## REMARKS

Claims 1-46, 50-56, 59 and 60 are currently pending in the present application. The Specification has been amended solely to correct clerical errors or improve readability, and corrected Figures 1, 2, 6, 7A, 9, 12-16 and 18 are included with the Request for Drawing Change submitted with this response.

In the Office Action mailed October 11, 2001, claims 1-14, 18, 19, 23-31, 33, 35-38, 42-46, 50-56, 59 and 60 were rejected and claims 15-17, 20-22, 32, 34 and 39-41 were allowed. More specifically, the status of the application in light of this Office Action is as follows:

FIG. 1

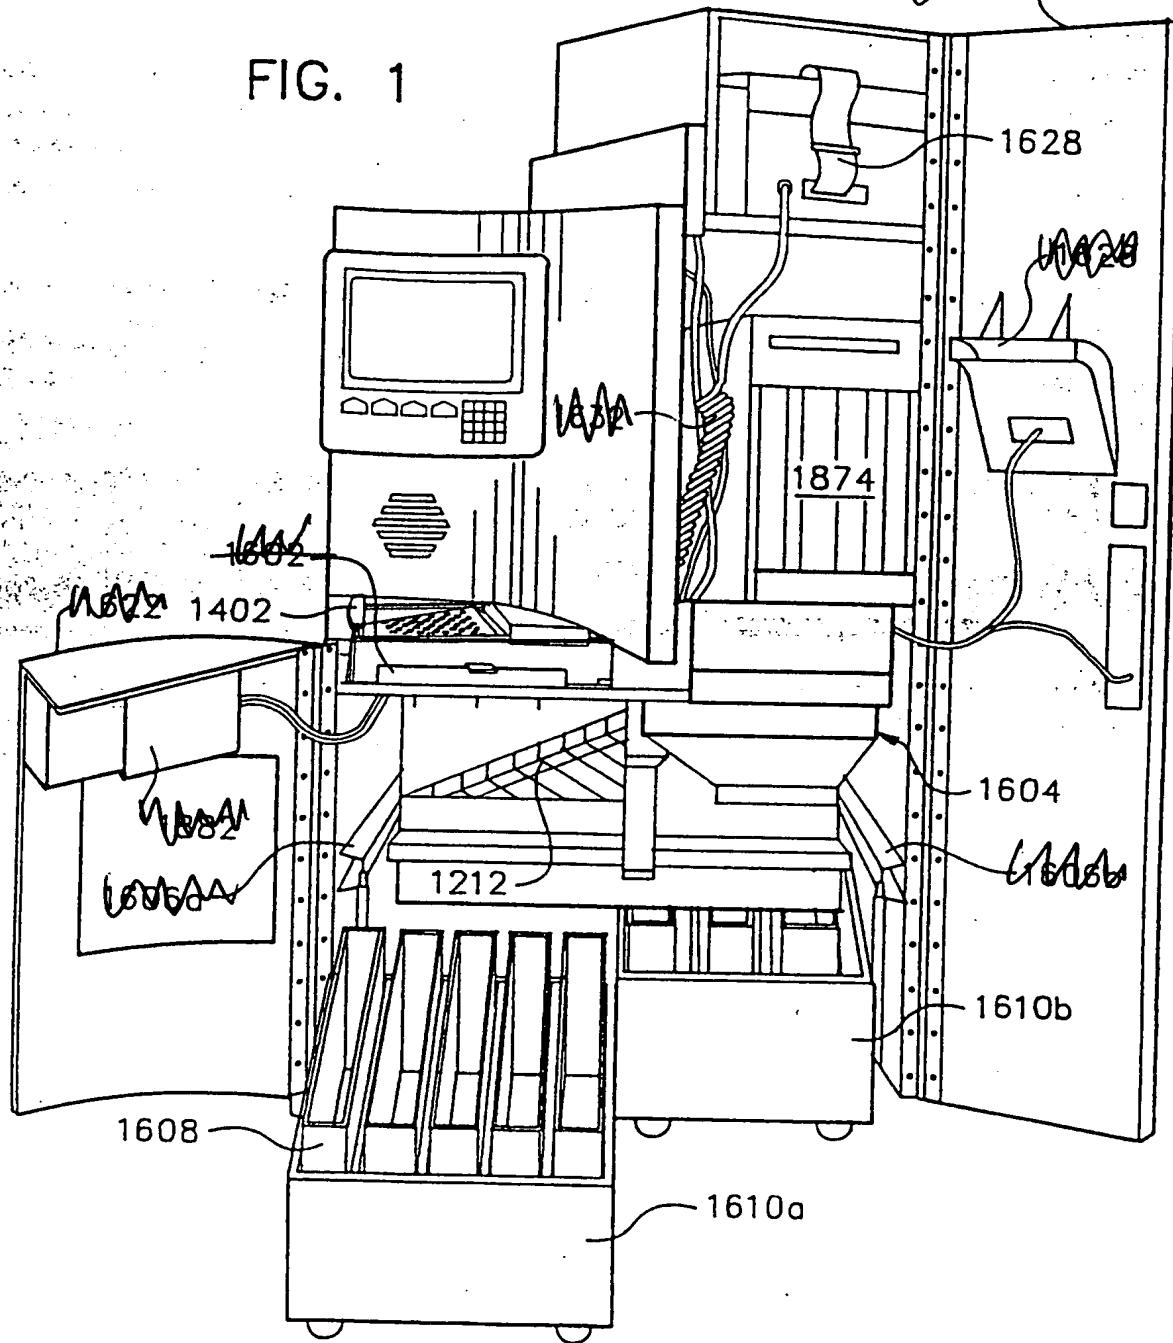
Figure 1 was objected to because the reference numbers 1602, 1606a, 1606b, 1622, 1624, 1626, 1632 and 1882 shown in the figure were allegedly not mentioned in the description. A corrected Figure 1 without these reference numbers has been provided in the Request for Drawing Change submitted in response to this Office Action.

FIG. 2

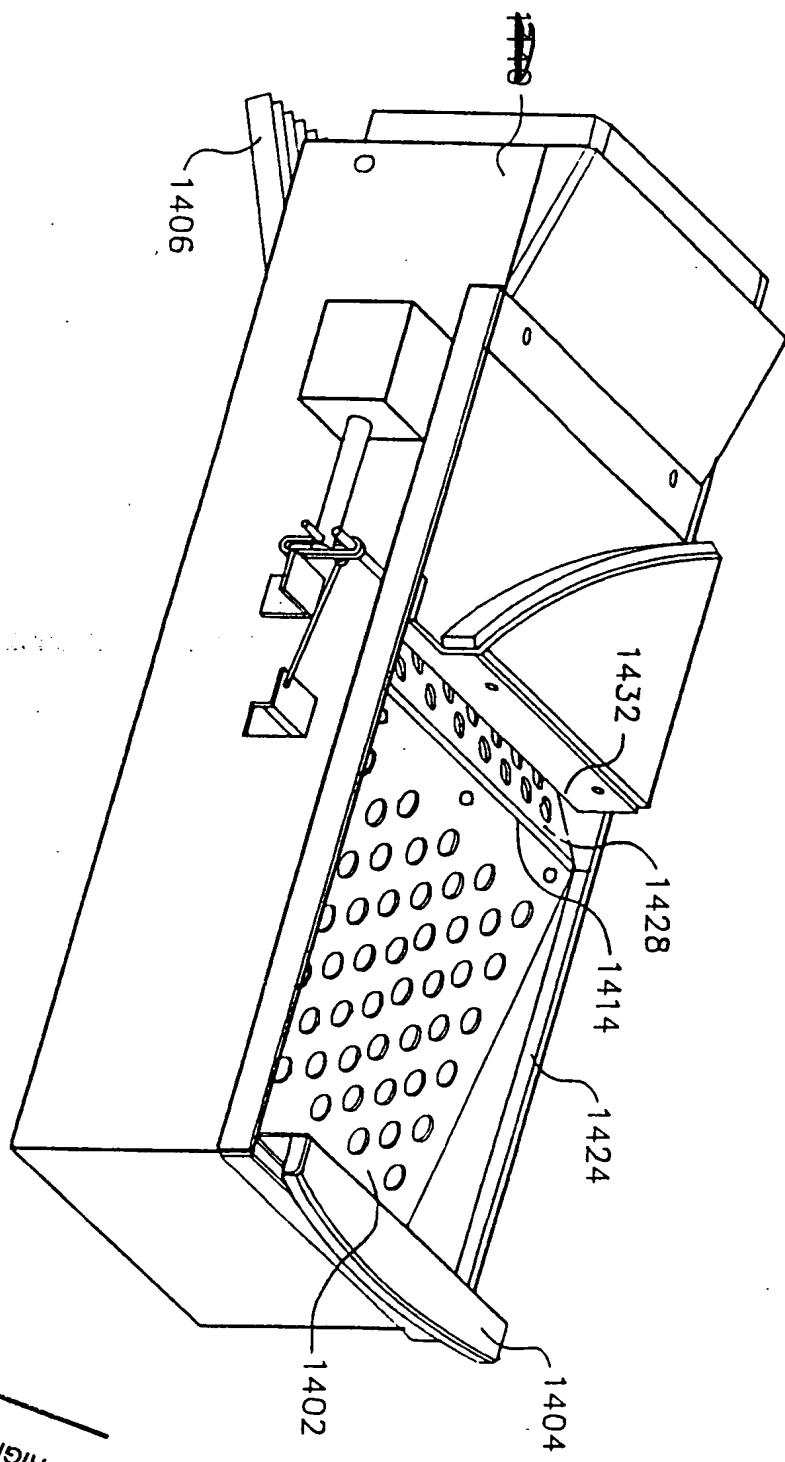
Figure 2 was objected to for including reference numbers 1440 and 1432 which allegedly are not mentioned in the description. A corrected Figure 2 without reference number 1440 has been provided in the Request for Drawing Change submitted in response to this Office Action. Applicants respectfully disagree with the Examiner's assertion that reference number 1432 is not mentioned in the description. Applicants direct the Examiner's attention to page 3, line 29: "... for movement past *a gate 1432*, ..." Accordingly, removal of reference number 1432 from Figure 2 is not required.

FIG. 6

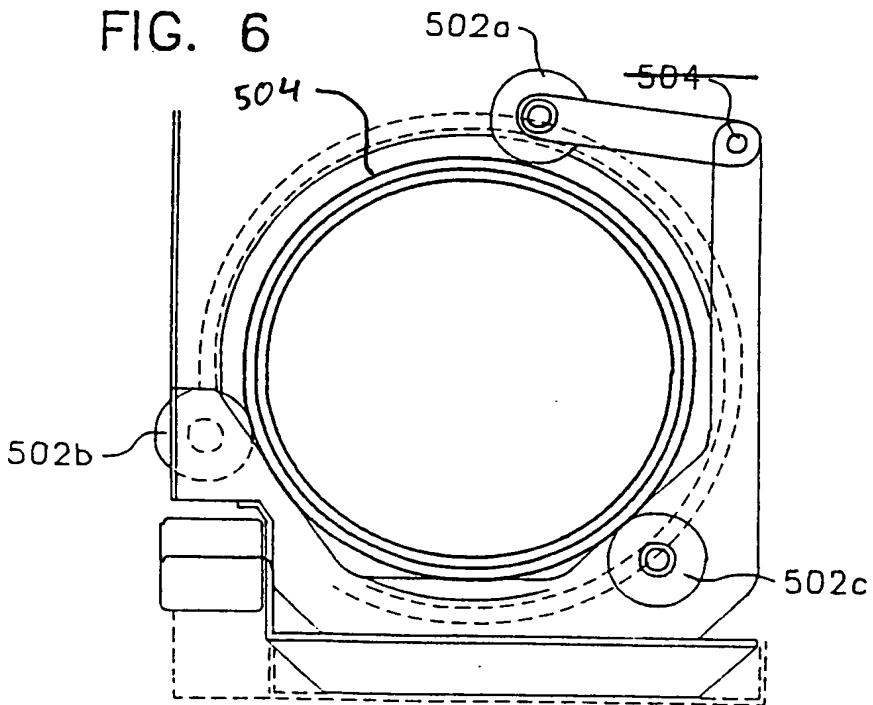
Figure 6 was objected to because the lead line of reference number 504 allegedly points to an incorrect element. A corrected Figure 6 showing the reference number 504 pointing to a race or annular recess, as described at line 33 on page 13 of the

Specification, has been provided in the Request for Drawing Change submitted in response to this Office Action.

FIG. 5

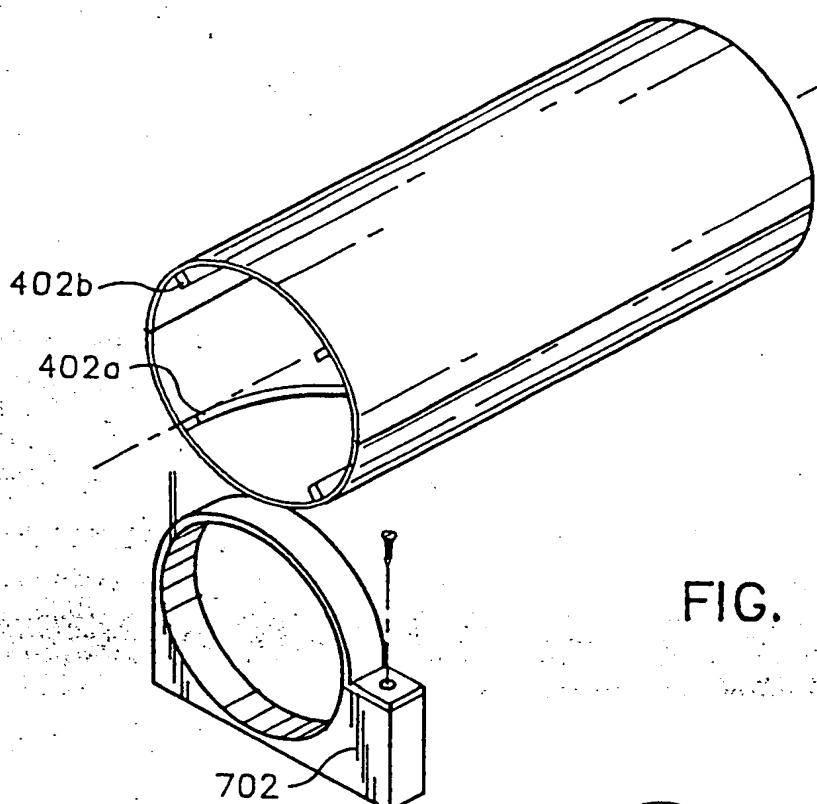
Figure 5 was objected to for including reference number 316 which allegedly was not mentioned in the description. Applicants respectfully disagree with the Examiner's assertion that reference number 316 is not mentioned in the description, and would like to direct the Examiner's attention to page 12, line 5: "... and via *chute 316* ..." Accordingly, removal of reference number 316 from Figure 5 is not required.

FIG. 7A

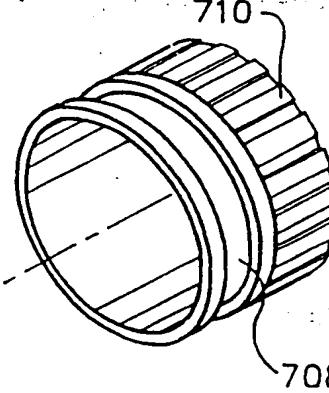
Figure 7A was objected to for allegedly being mislabeled. A corrected Figure 7 labeled "Figure 7" instead of "Figure 7A" has been provided in the Request for Drawing Change submitted in response to this Office Action.

FIG. 9

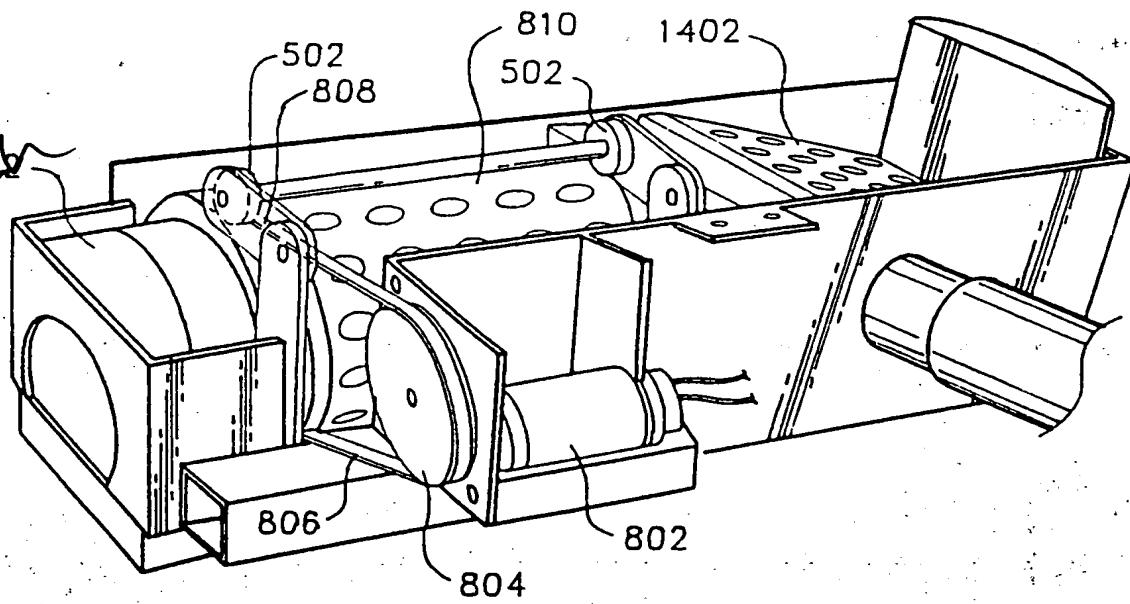
Figure 9 was objected to for including reference number 812 which allegedly is not mentioned in the description. A corrected Figure 9 without reference number 812 has been provided in the Request for Drawing Change submitted in response to this Office Action.

FIG. 12

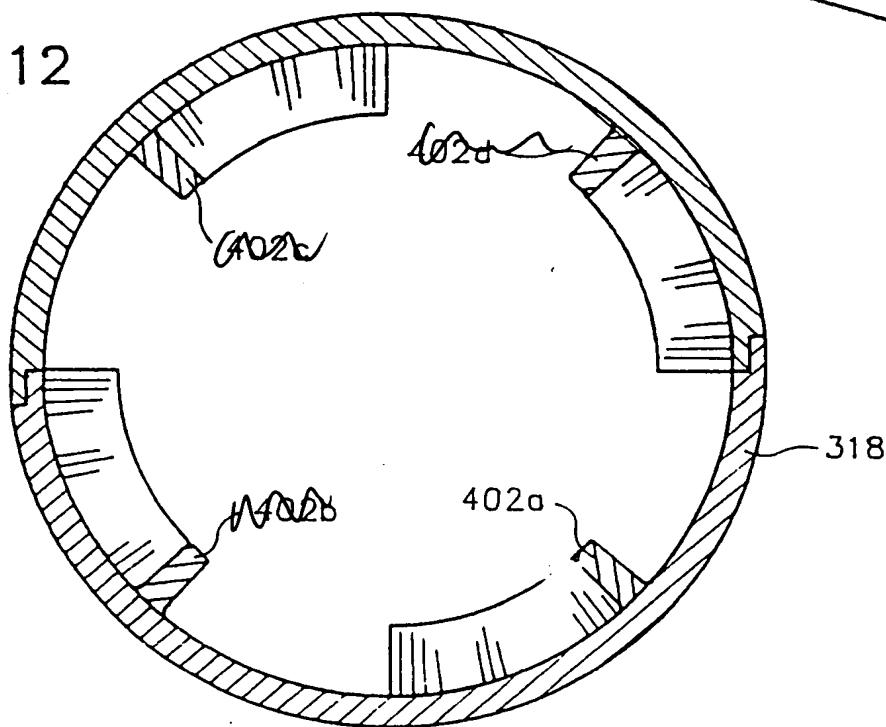
Figure 12 was objected to for including reference numbers 402b, 402c, and 402d which allegedly are not mentioned in the description. A corrected Figure 12 without the reference numbers 402b, 402c and 402d has been provided in the Request for Drawing Change submitted in response to this Office Action.

FIG. 13

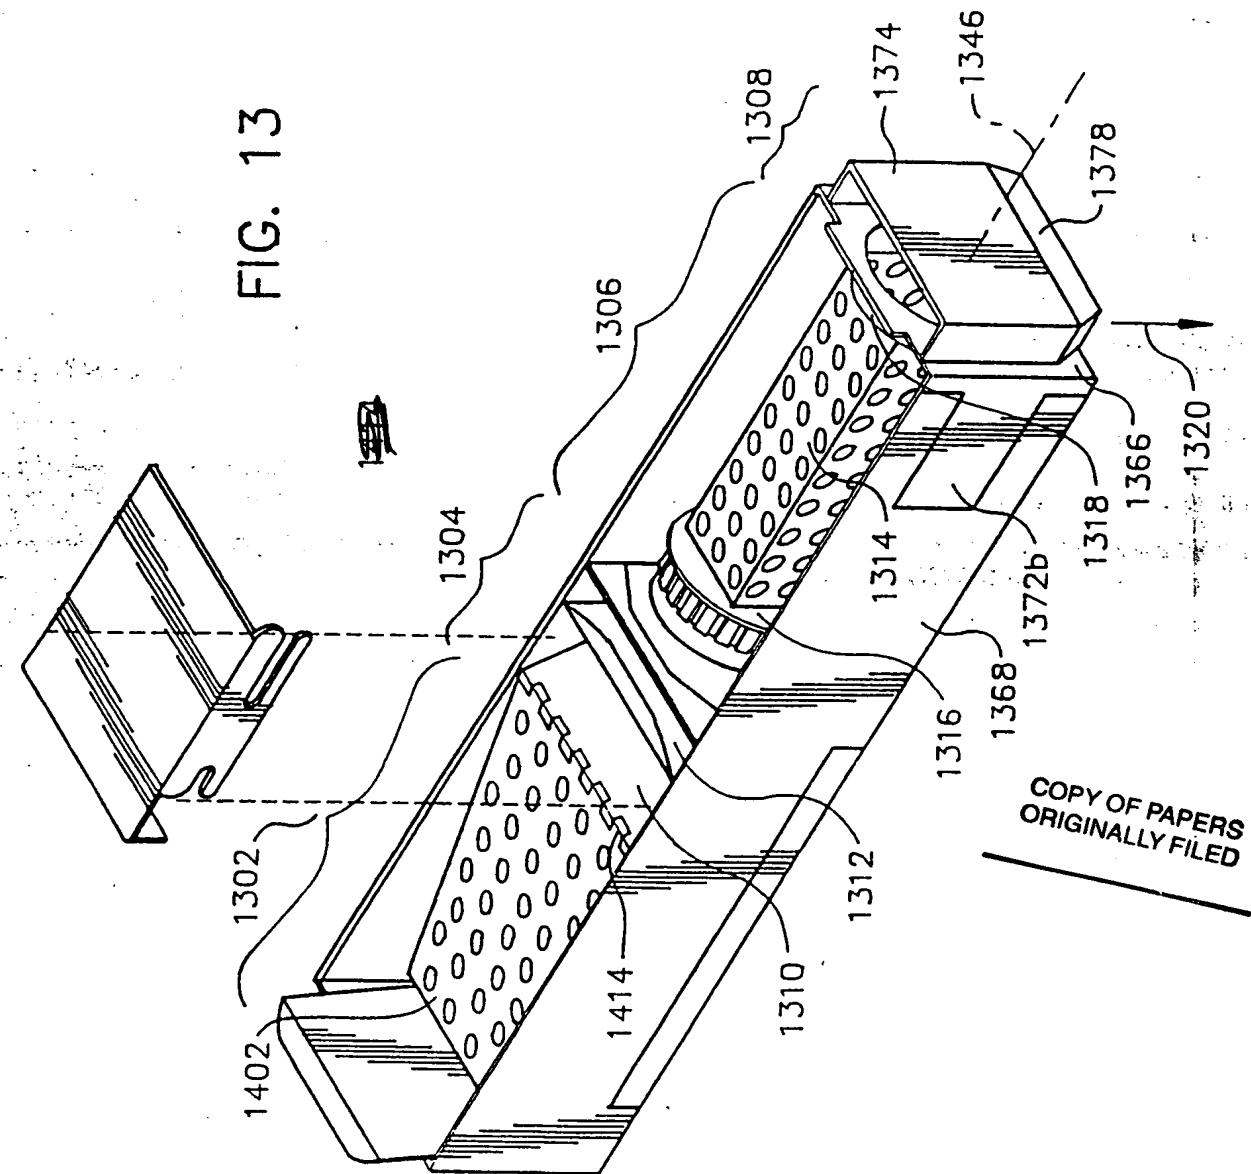
Figure 13 was objected to for including reference number 1414 which allegedly was not mentioned in the description. Applicants respectfully disagree with the Examiner's assertion that reference number 1414 is not mentioned in the description, and would like to direct the Examiner's attention to page 3, line 28: "... over the *ridge or peak 1414*, . . ." Accordingly, no correction to Figure 13 in this regard is required.

FIG. 14

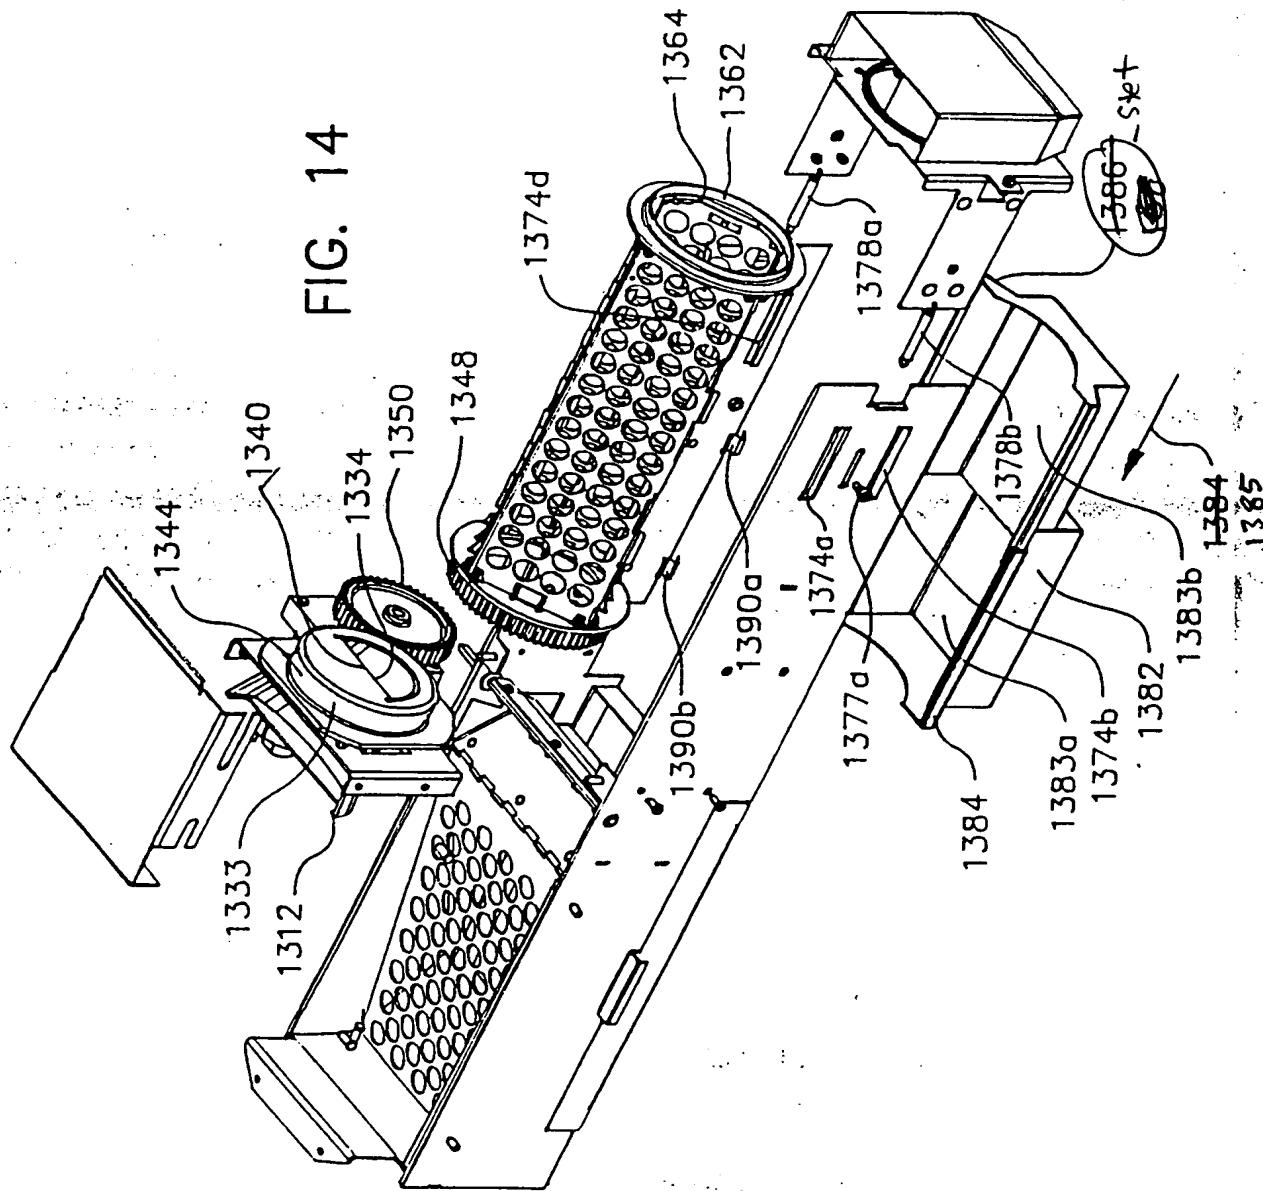
Figure 14 was objected to because the directional arrow was allegedly mislabeled as "1384" when it should have been labeled "1385." A corrected Figure 14 showing the directional arrow labeled as 1385 has been provided in the Request for Drawing Change submitted in response to this Office Action.

FIG. 15

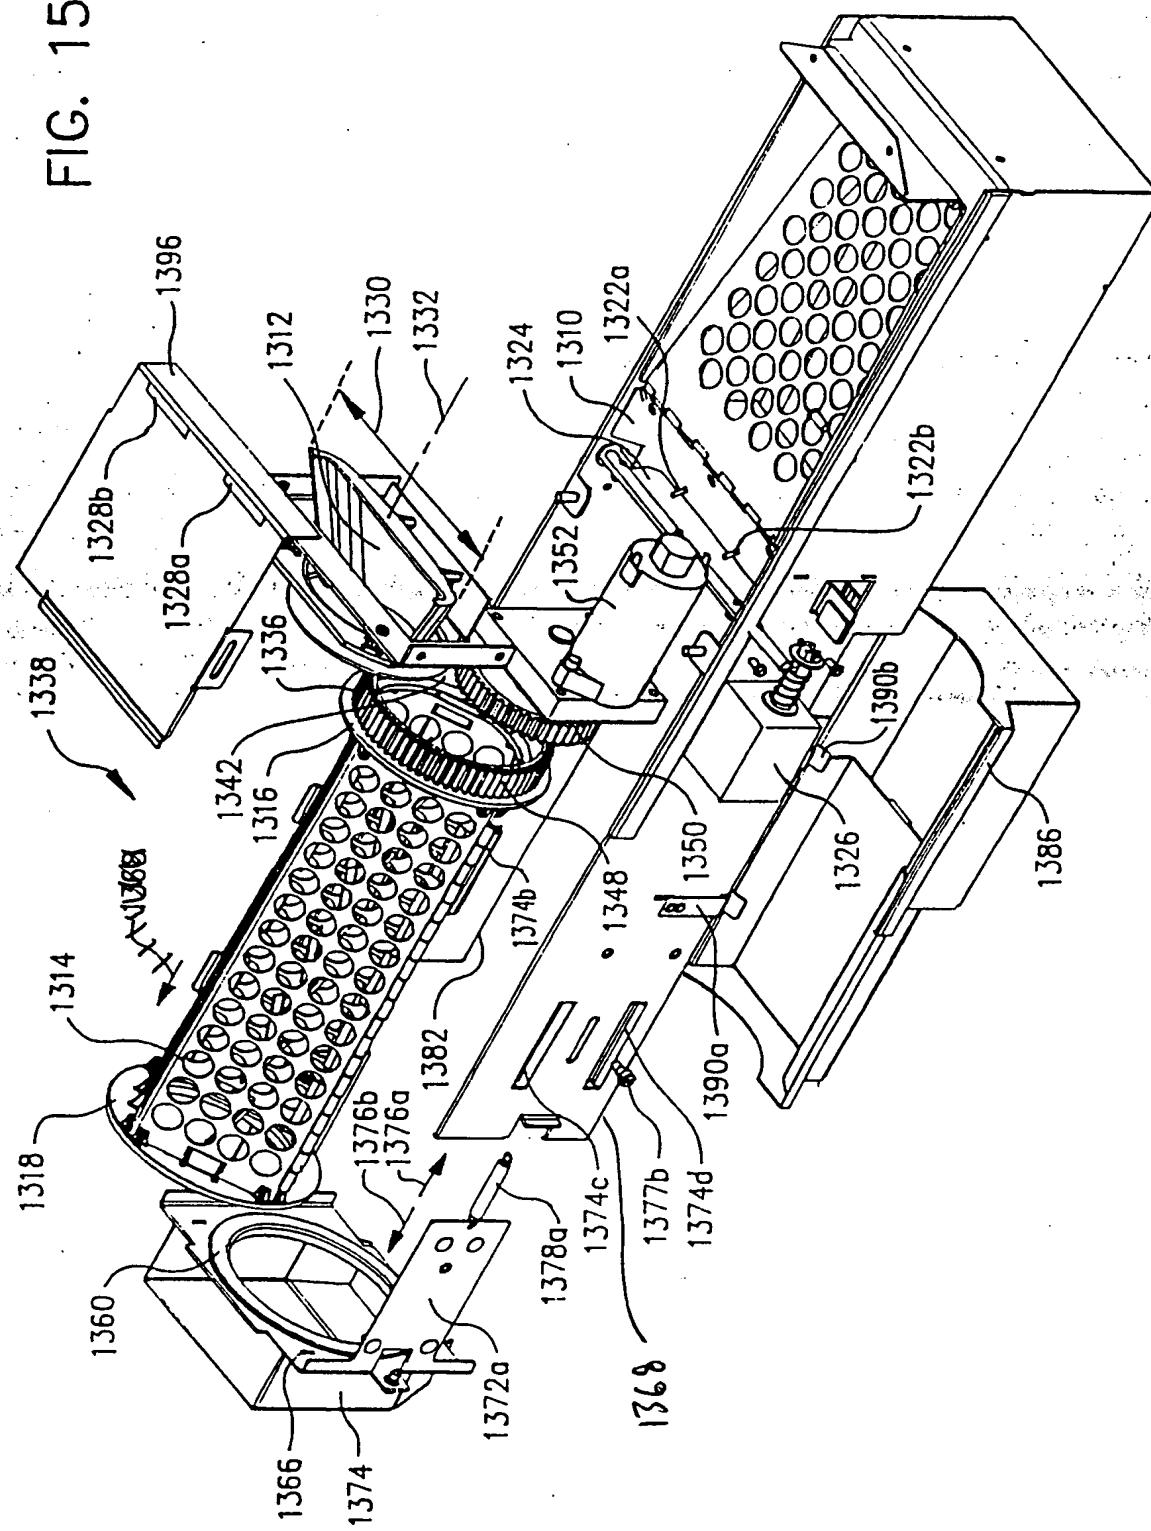
Figure 15 was objected to because the directional arrow was allegedly mislabeled "1368" when 1368 should refer to the frame. A corrected Figure 15 identifying the frame as 1368 and eliminating the reference to the directional arrow has been provided in the Request for Drawing Change submitted in response to this Office Action.
